BEACON LITE ROAD STOCKPILE CONSTRUCTION DRAWINGS AMENDMENT

EDARP FILE NO.: CDR261

V5_Grading & Erosion Control (GEC) Plan_comments.pdf Markup Summary

BEACON LITE ROAD STOCKPILE
PERMANENT CONTROL MEASUREMENT
PLAN - POND "B"

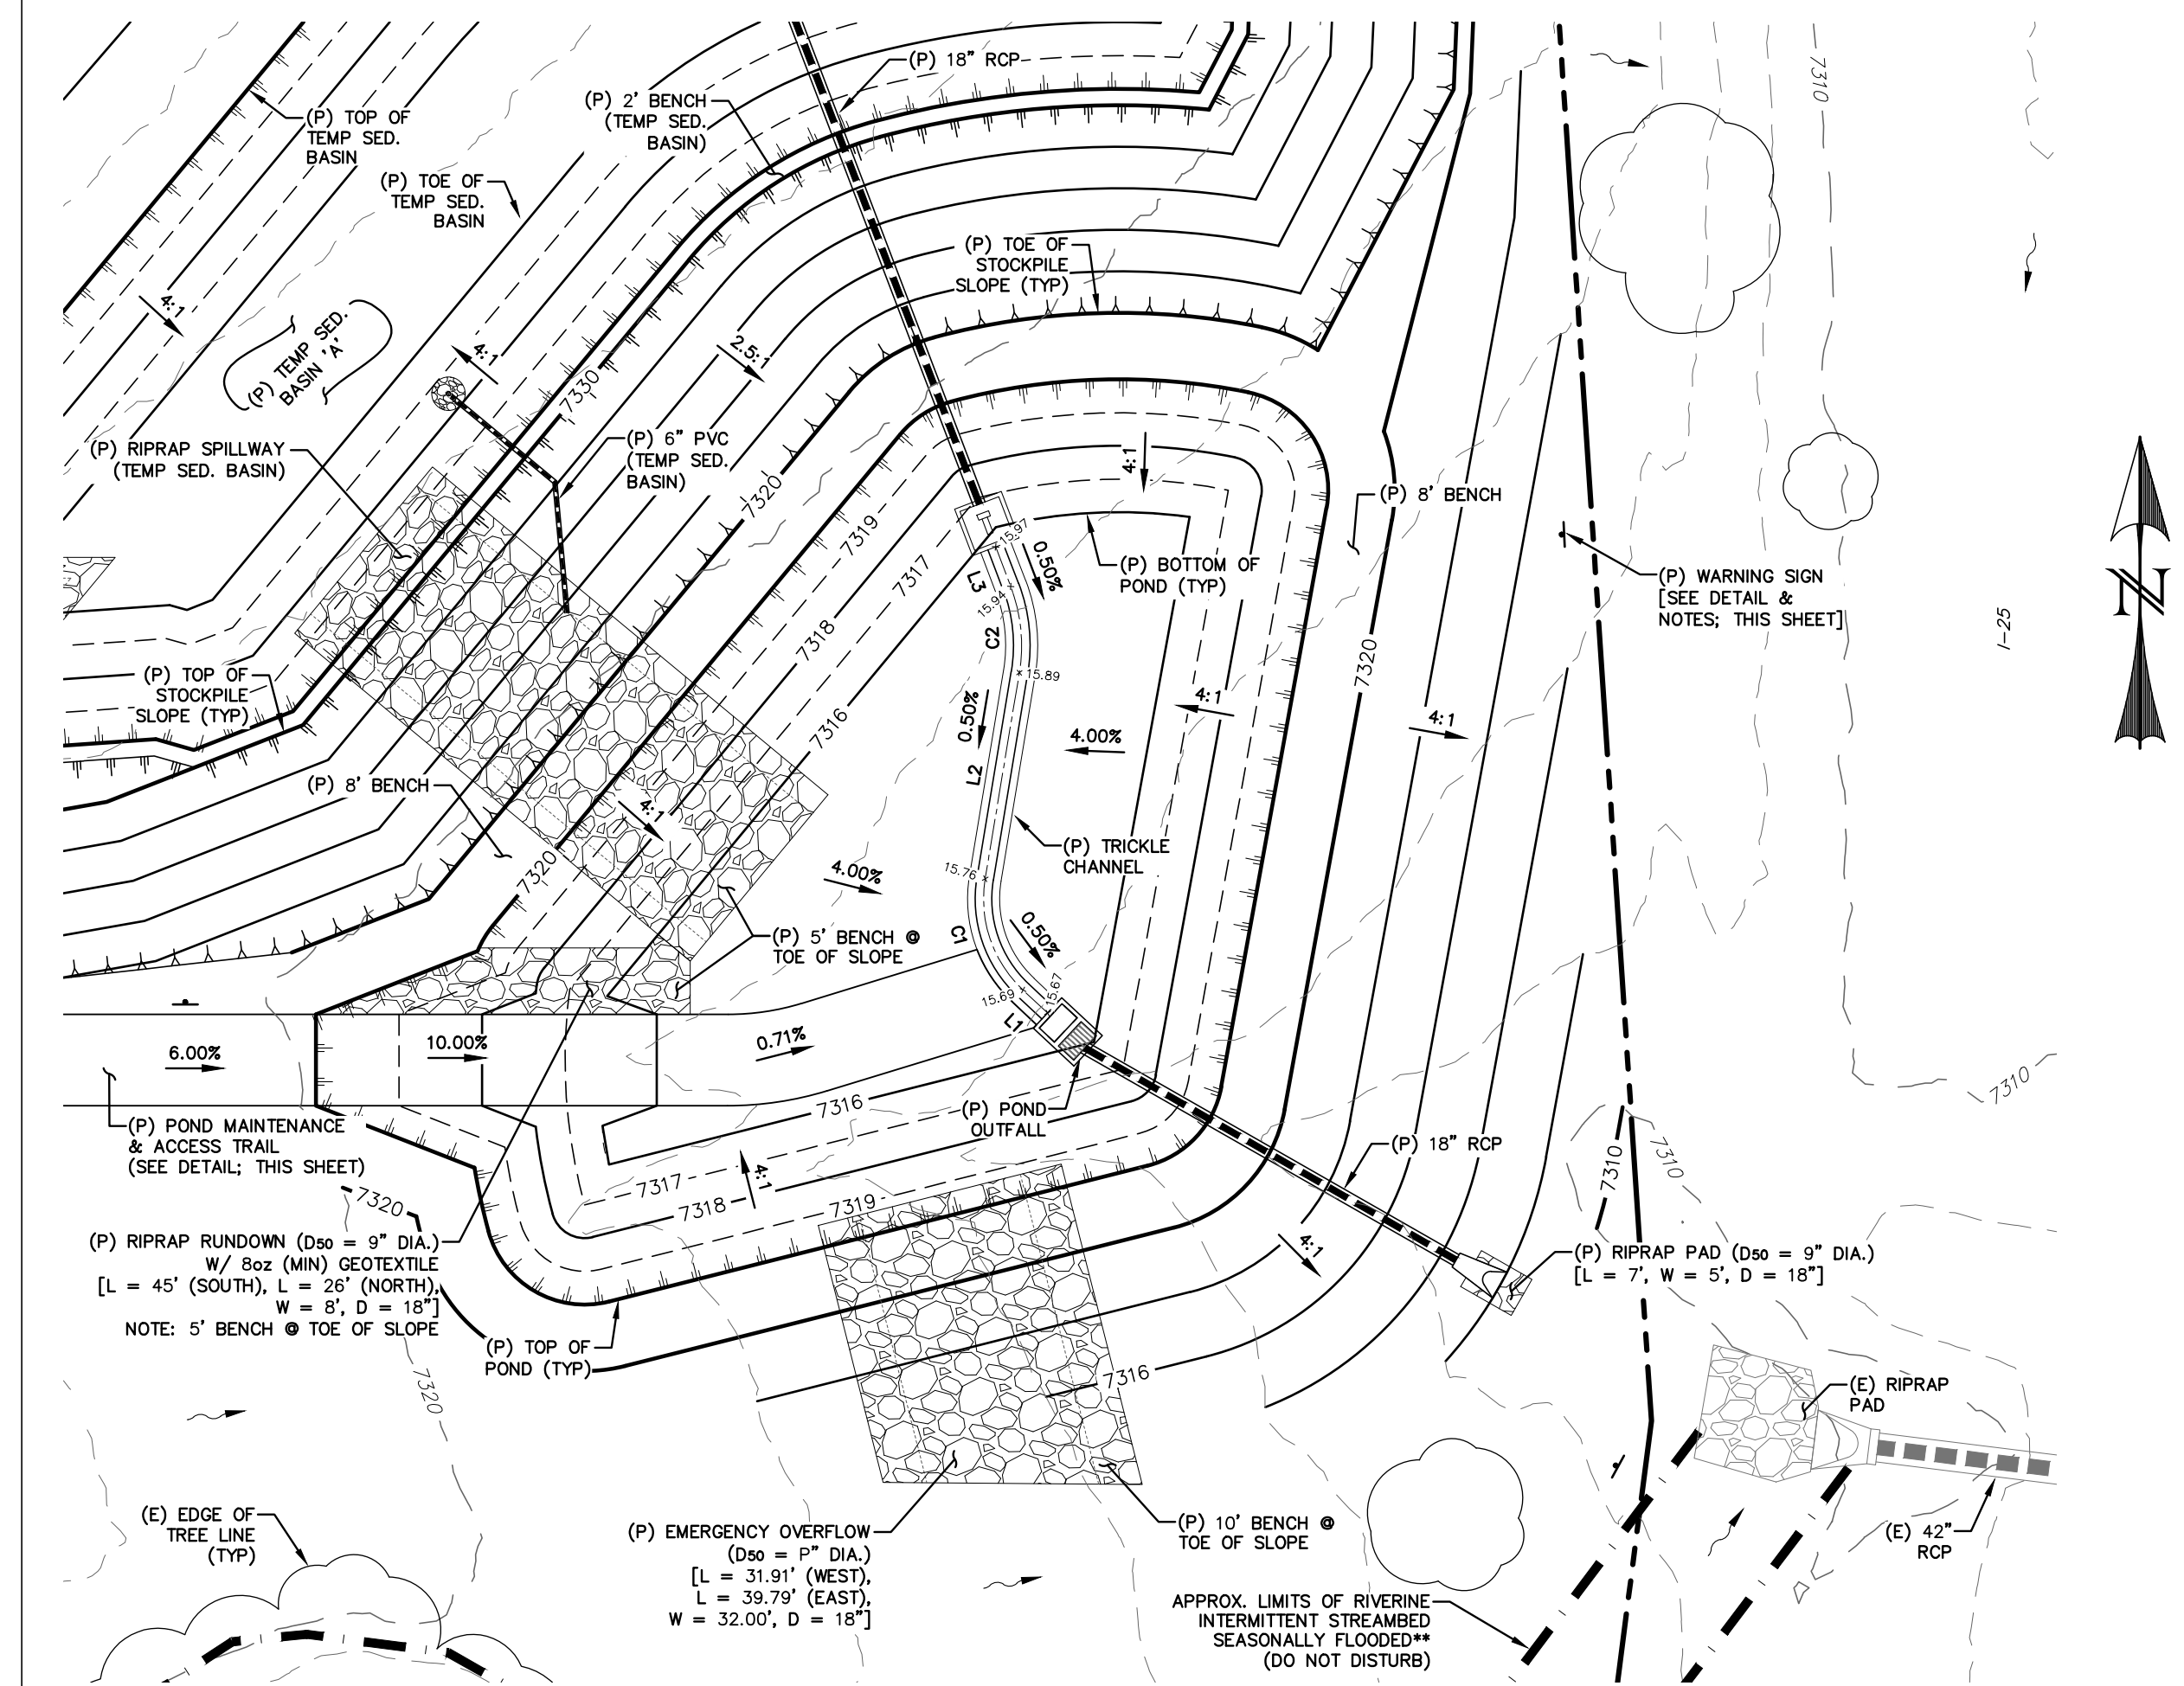
Revise text for size discrepancy. Calcs and detail in upper left of this sheet show 2.5'x4'

Revise text for size discrepancy. Calcs and detail in upper left of this sheet show 2.5'x4'

ORIFICE PLATE
SCALE: N.T.S.

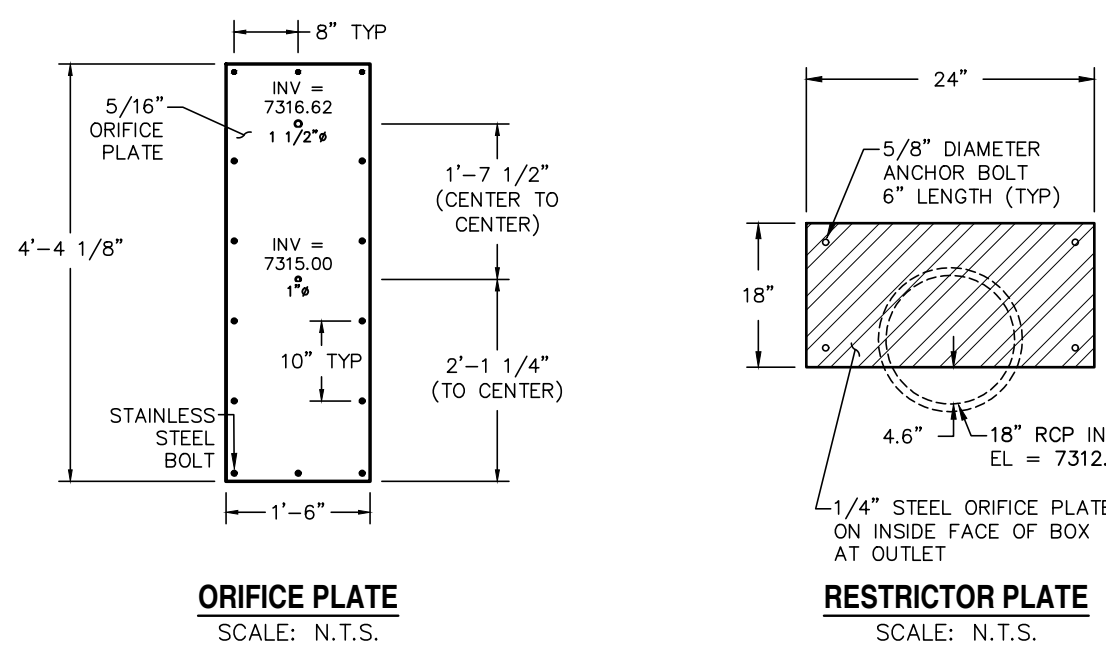
Please provide more detailed gasket info like thickness, width, brand/model, etc.

Please provide more detailed gasket info like thickness, width, brand/model, etc.

The gasket shall be made of 1/4-inch thick, 60 durometer EPDM rubber in a continuous sheet the size of the orifice plate. The sheet shall be placed between the orifice plate and the concrete wall, with the width of the overlap between the plate and the concrete. Openings shall be cut into the sheet corresponding to the plate bolt holes and the concrete wall opening, cuts made either by the contractor in the field or by the manufacturer. Or equivalent gasket approved by EPC. Note that caulk is not an approved equivalent and will not be accepted by EPC.

The gasket shall be made of 1/4-inch thick, 60 durometer EPDM rubber in a continuous sheet the size of the orifice plate. The sheet shall be placed between the orifice plate and the concrete wall, with the width of the overlap between the plate and the concrete. Openings shall be cut into the sheet corresponding to the plate bolt holes and the concrete wall opening, cuts made either by the contractor in the field or by the manufacturer. Or equivalent gasket approved by EPC. Note that caulk is not an approved equivalent and will not be accepted by EPC.
